Platt Technical High School

ADDENDUM NO. 4

August 9, 2019

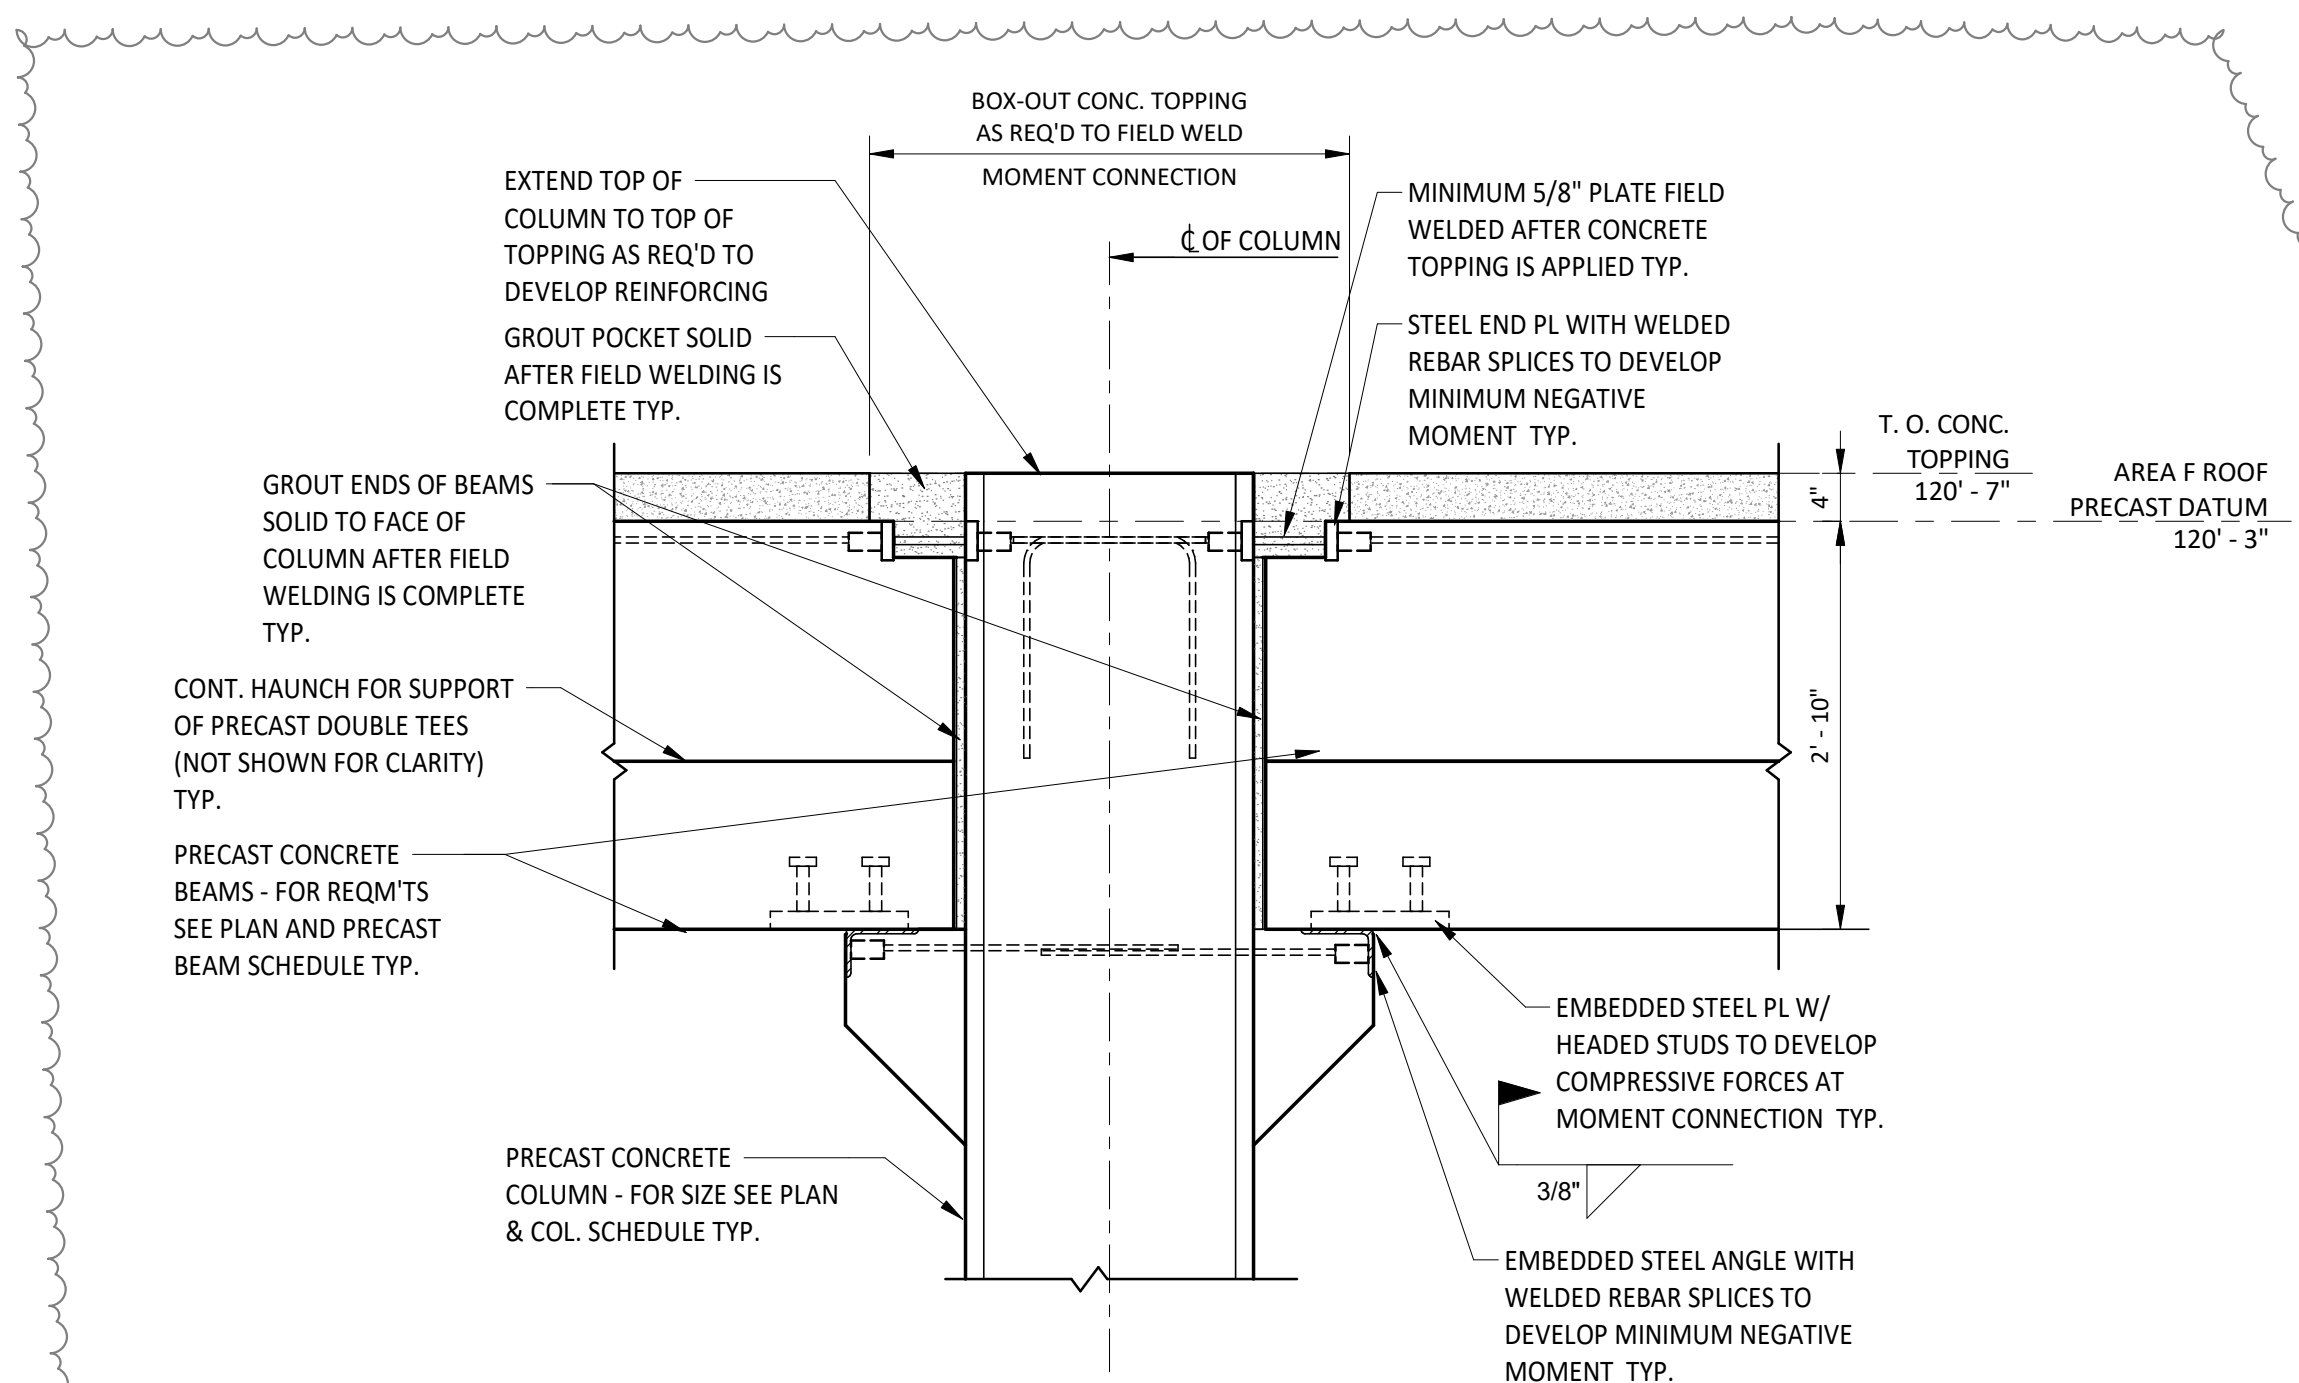
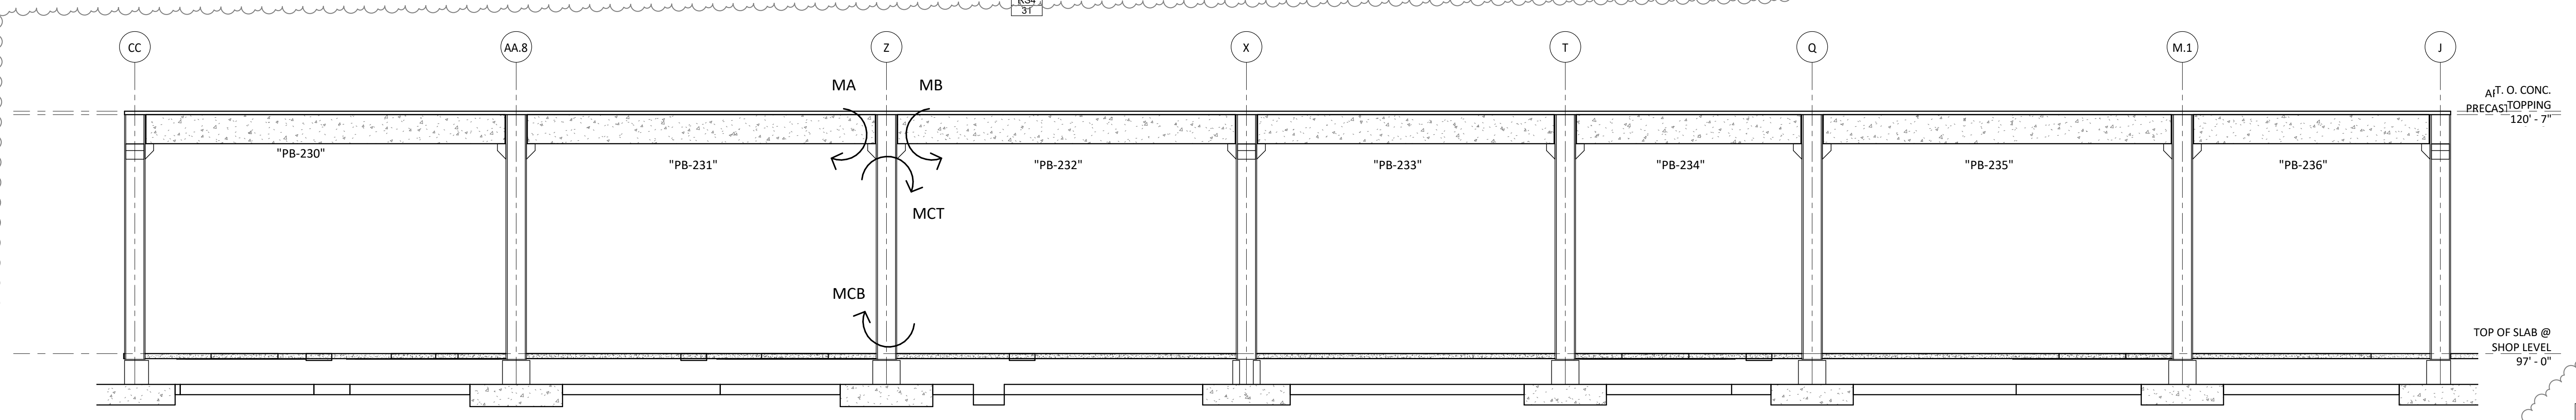
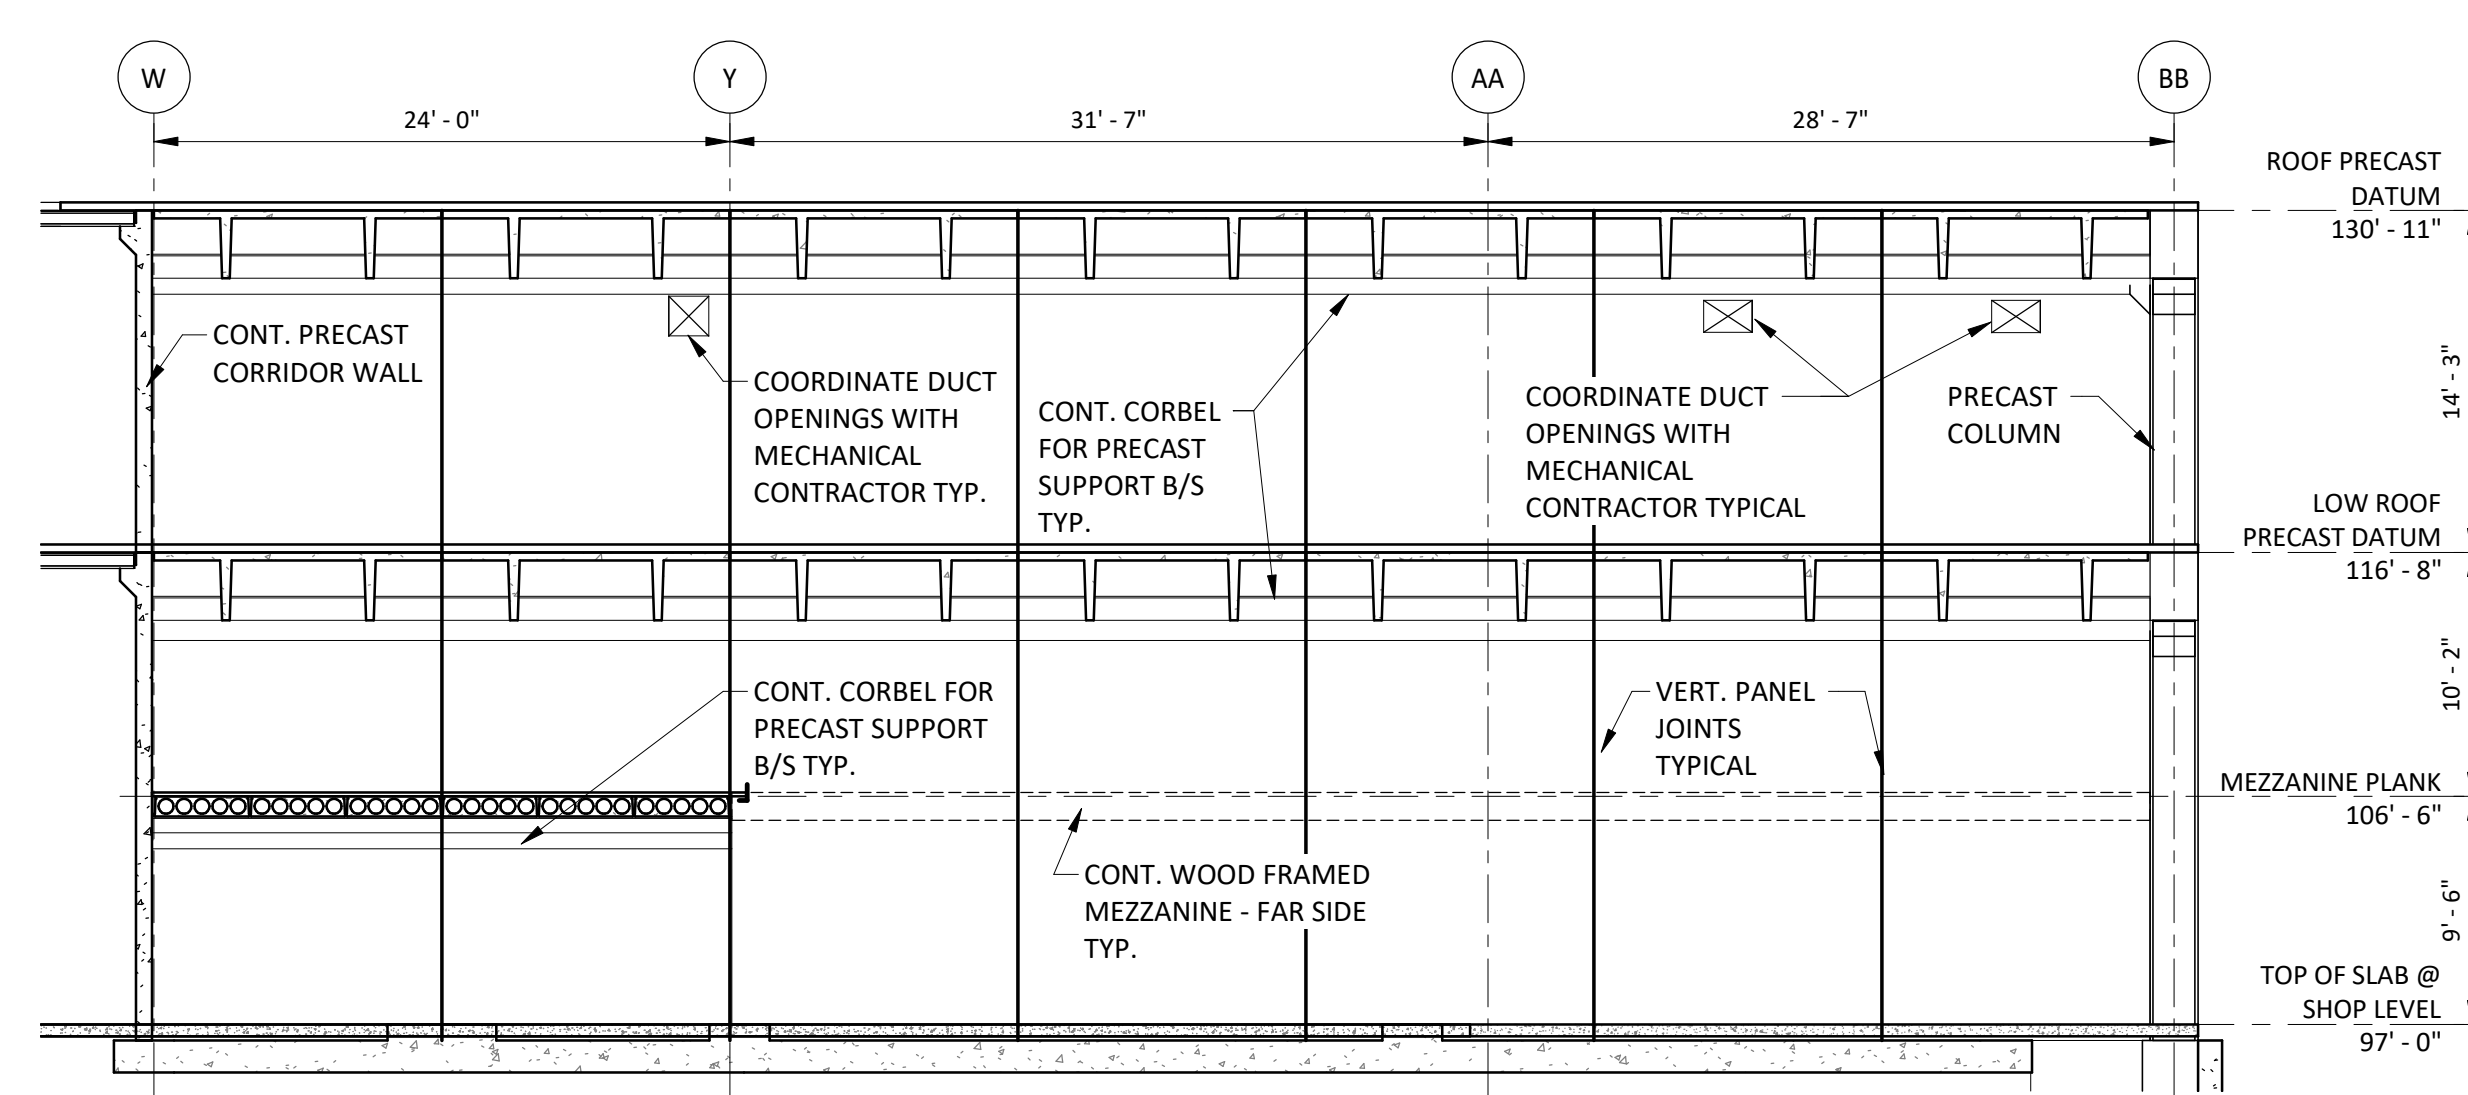
- ADD 4-119 DRAWING S2-1-4 – PRECAST COLUMN SCHEDULE**
Revised precast columns per Revision RS4-29.
Added plan note #9 per Revision RS4-30.
Added precast moment frame elevation, section and notes per Revision RS4-31.
